FILE NUMBER: Z234-110(LC) **DATE FILED:** October 19, 2023

REQUEST: An application for 1) a new Planned Development District for R-1ac(A) Single Family District uses; and 2) the termination of Specific Use Permit No. 580 for a private school with consideration for a Specific Use Permit for a private school on property zoned an R-1ac(A) Single Family District.

STAFF RECOMMENDATION: **Approval** of a Specific Use Permit for a private school for a ten-year period, subject to staff's recommended conditions and a revised site plan, in lieu of a Planned Development District.

STAFF'S RECOMMENDED SUP SITE PLAN

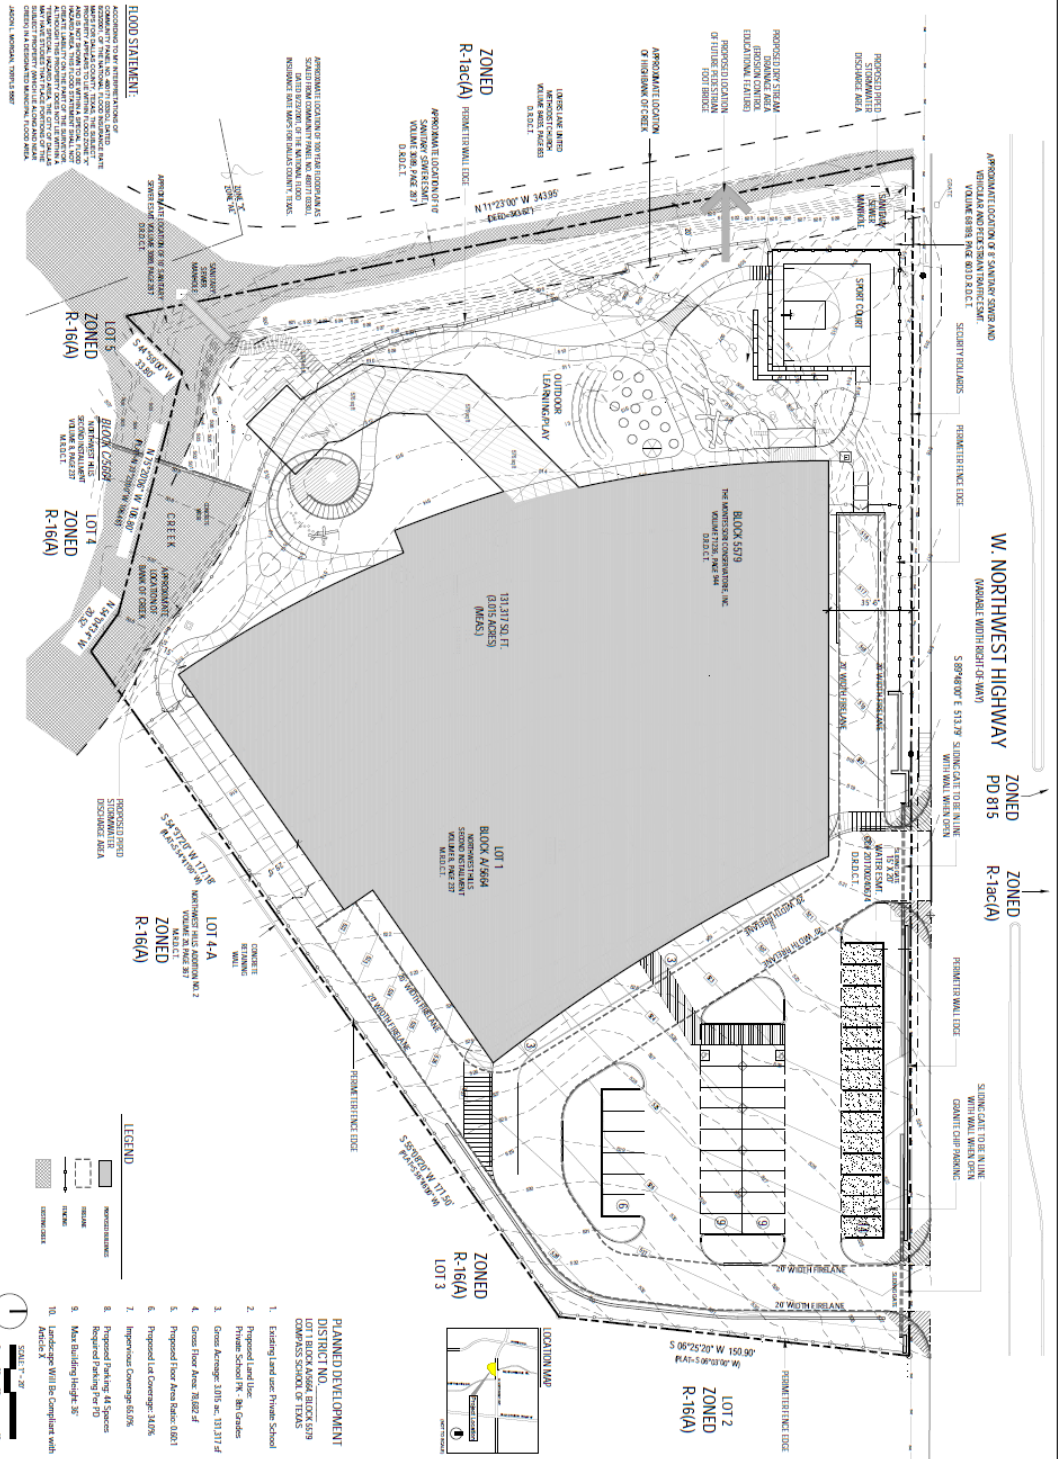
To operate under an SUP, the applicant would need only make minor adjustments to the site plan, including:

1. Shifting the front building façade south by about 5 feet to accommodate the front yard.
2. Remove parking from the front yard, required parking for institutional uses can be addressed through an SUP if necessary.

Other revisions using the PD are likely not necessary, the buildings comply with the side and rear setbacks and the horizontal portions of the sport court can be located within the setback given, vertical elements are behind the setback line. The fence height adjustment

Compass School of Texas - Four Dismissals*
 *Mitigation option if queue extends further than projected at buildout. See TMP with 3 dismissal periods within report.

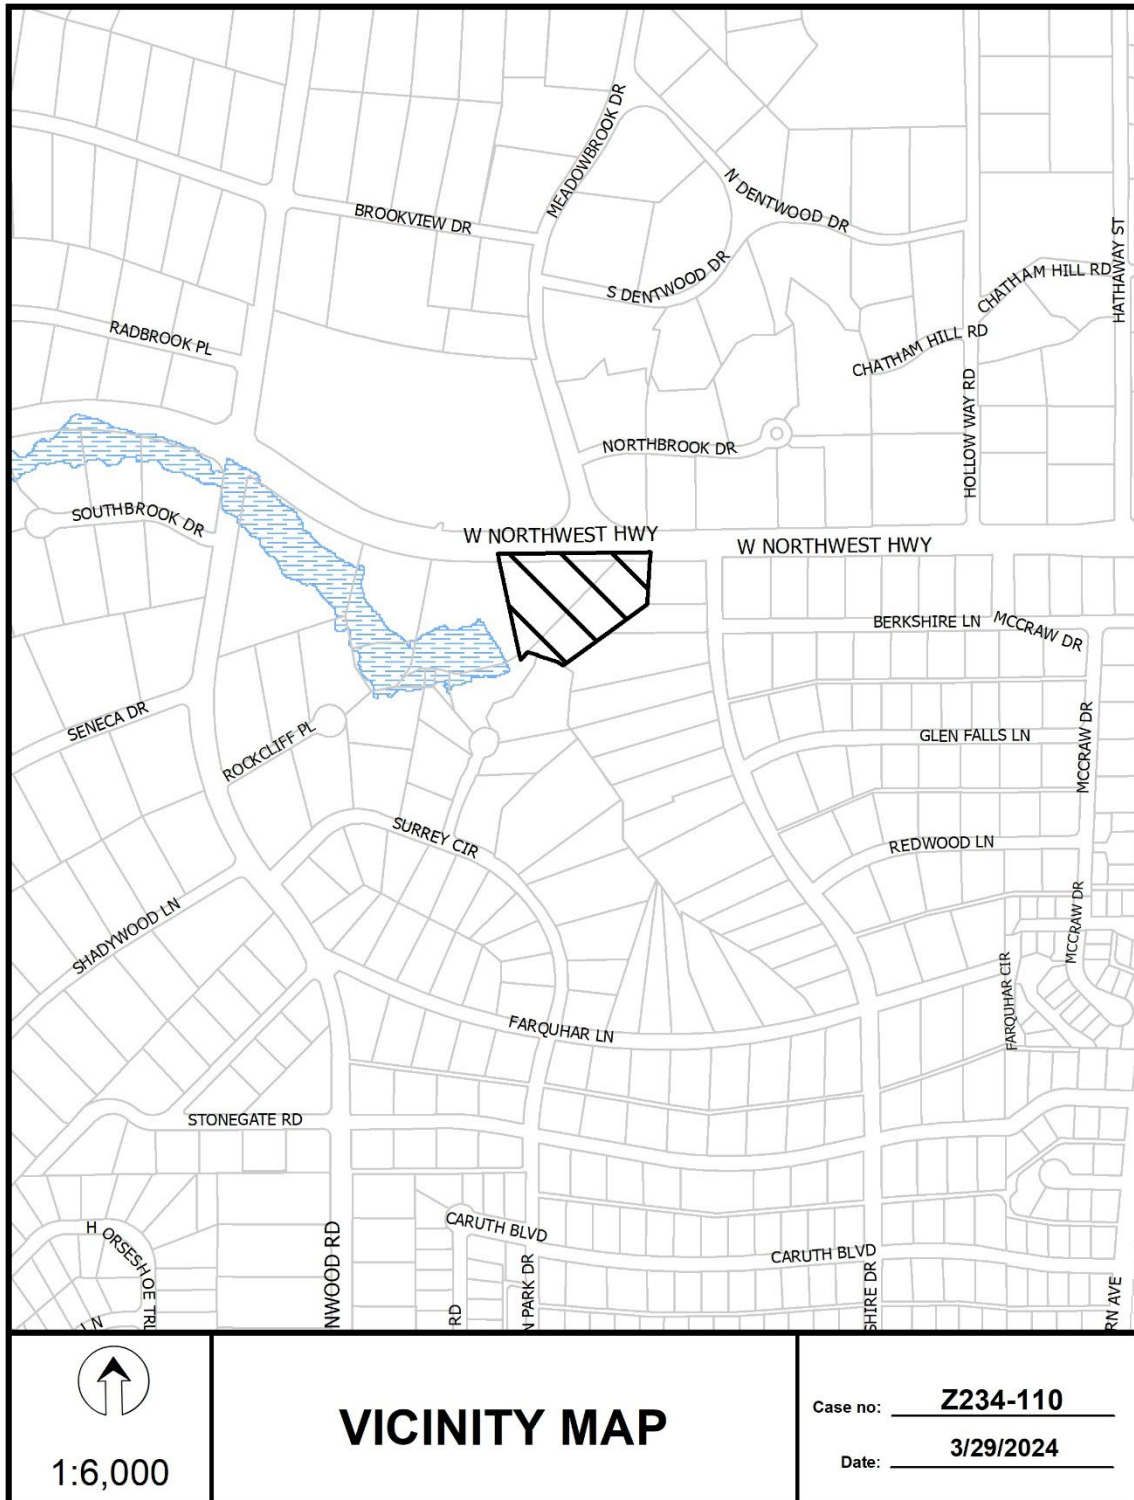
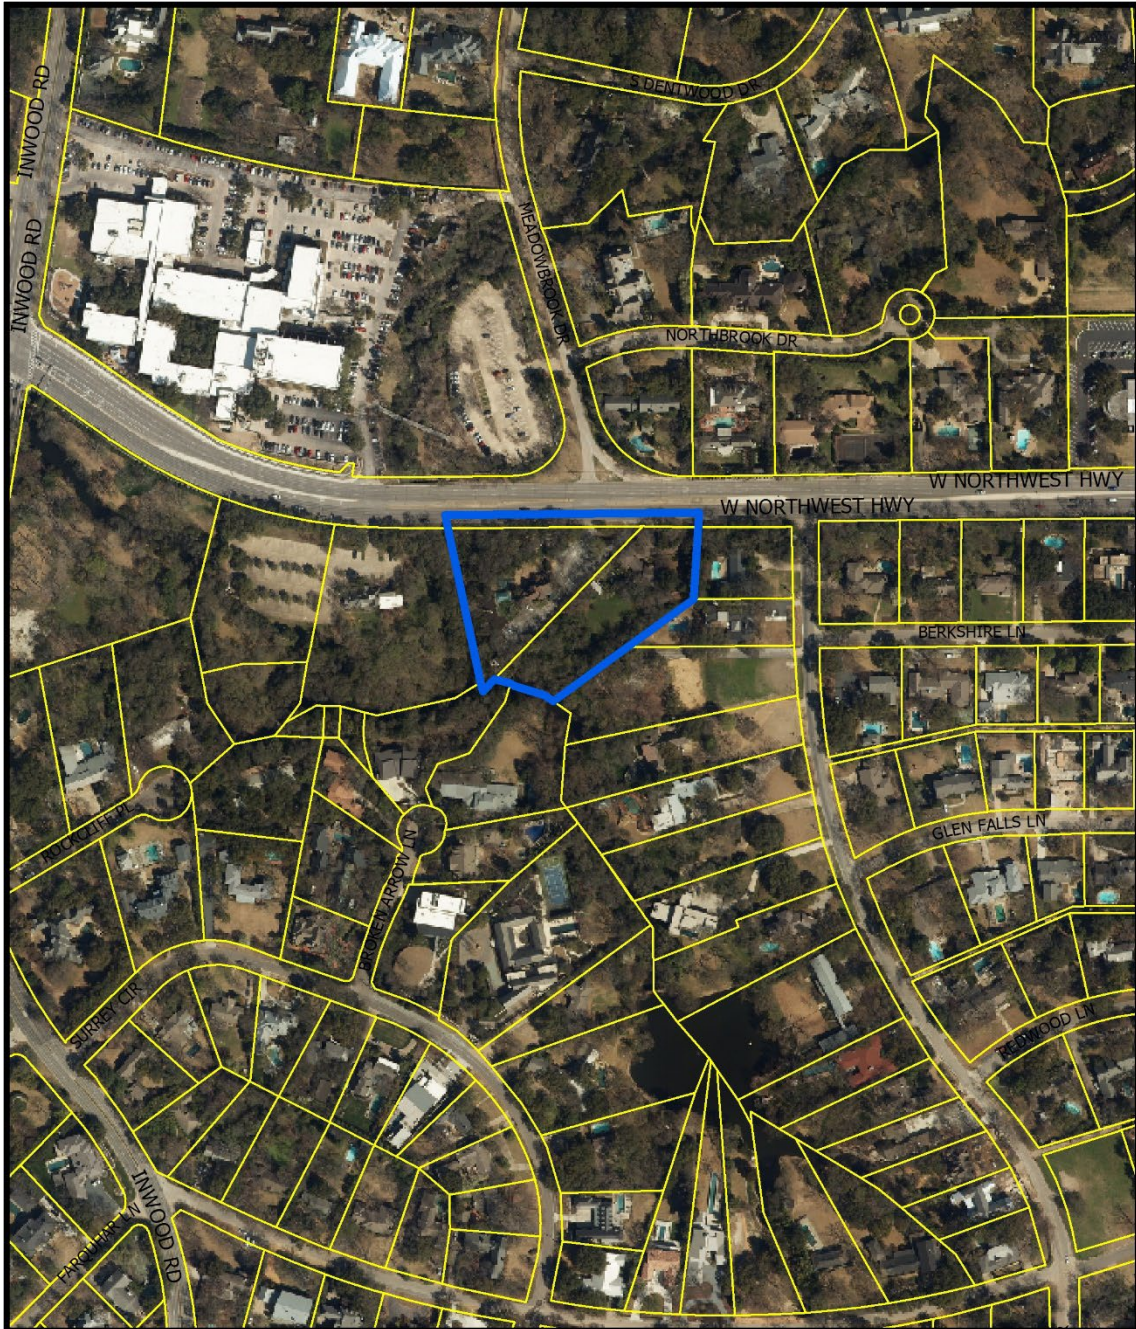
The engineering division of Planning and Development Department completed a review of a traffic management plan dated February 29, 2024. The report proposes to split dismissal times into three student cohorts separated by 20 minutes each. The school expansion is anticipated to saturate two lanes for queuing operations at school’s full capacity. The success of the proposed operations is contingent on the operator’s ability to actively manage school traffic. Failure to do so would spill a queue back onto a high-speed corridor, also impeding access to emergency response vehicles.

The application also acknowledges that the subject site is locked away from any local road—access is limited to motor vehicles on West Northwest Highway. The mitigation plan places traffic cones at the main driveway, forcing westbound traffic to make U-turns in order to enter the site. Construction plans will revise proposed site plan to improve visibility; meeting minimum visibility triangles is not sufficient. Design must comply with sight distance standards, based on roadway features such as observed and vertical curvature. The operations plan also explores the possibility of adding an additional dismissal period. Staff does not agree a fourth period would be a practical solution unless separated by no less than 20 minutes.

Engineering staff has no objection to the proposed traffic management plan, subject to conditions that allow the school to gradually monitor site operations before ultimate building expansion.
